Access Compliance Report

Public Rights-of-Way

Intersection ID: 8285	Main Street: CATHERINE_SIMMONS_AV	Cross Street: HAINES_ST	Location: SE
ADA ID: 38979A17B4A3	Ramp Type: BlendTrans1	Initial Pass/Fail: Pass	Overall Compliance: No
Severity Score: 7.75			
Codes/Mitigation Info/Possible Solution		Field Measurements/Component Compliance

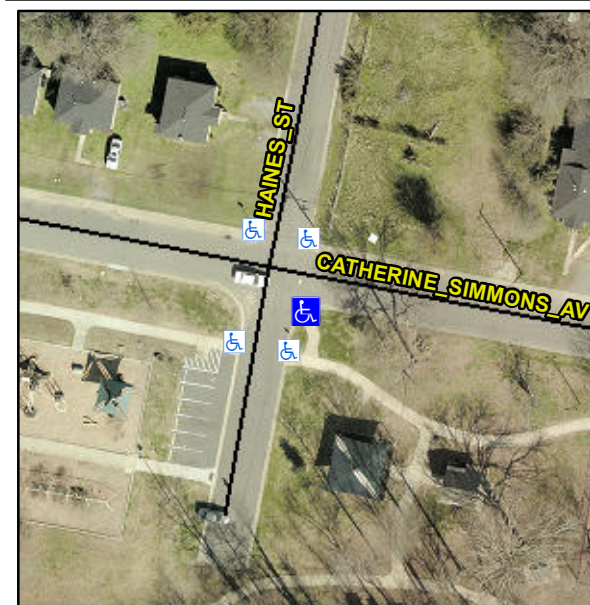
Not Found, R304.5.3, R305.2, R302.7, R302.7.2

Compliance	Description	Data	Compliance	Description	Data
N/A	Ramp Length (in)	71.5	Yes	BlendTrans Slope (%)	2.5
Yes	Ramp Width (in)	71.5	No	BlendTrans XSlope (%)	2.7
N/A	Flare Type LT	Sloped	N/A	Flare Type RT	Sloped
N/A	Flare Slope LT (%)	3.4	N/A	Flare Slope RT (%)	0.4
N/A	Flare Traversable LT?	No	N/A	Flare Traversable RT?	No
Yes	Landing Length (in)	59.5	Yes	DWS Provided?	Yes
Yes	Landing Width (in)	73.0	Yes	DWS Contrast?	Yes
Yes	Landing Slope (%)	0.7	Yes	DWS Length (in)	24.0
No	Landing X Slope (%)	2.9	Yes	DWS Full Width?	Yes
N/A	Landing Curb? (Y/N)	No	No	DWS Offset (in)	4.5
N/A	Shared Landing?	No			
No	Gutter Ponding?	Yes	Yes	Gutter Slope (%)	3.5
No	Gutter Lip Ht (in)	0.5	Yes	Gutter X Slope (%)	0.5
N/A	Painted X Walk1?	No	N/A	Painted X Walk2?	N/A
	X Walk 1 Direction	To N		X Walk 2 Direction	N/A
	X Walk 1 Width (in)	N/A		X Walk 2 Width (in)	N/A
	X Walk 1 Slope (%)	3.4		X Walk 2 Slope (%)	N/A
	X Walk 1 X Slope (%)	1.8		X Walk 2 X Slope (%)	N/A

N/A	Ramp inside XWalk1?	N/A	N/A	Ramp inside XWalk2?	N/A
	Road Slope (%)	1.8		Clear Space?	Yes
	Road X Slope (%)	3.4	N/A	Clear Space to XWalk (in)	N/A
Yes	Any Obstructions?	No	Yes	Storm Grate/Utility Hazard?	No
	Obstruction Type			Storm Grate/Utility Type	
		N/A			N/A
			Yes	Surface Condition? (G/P)	Good
			No	Curb Slope (%)	6.0

Remove & Replace Curb Ramp With Two New Directional Ramps or Equivalent.
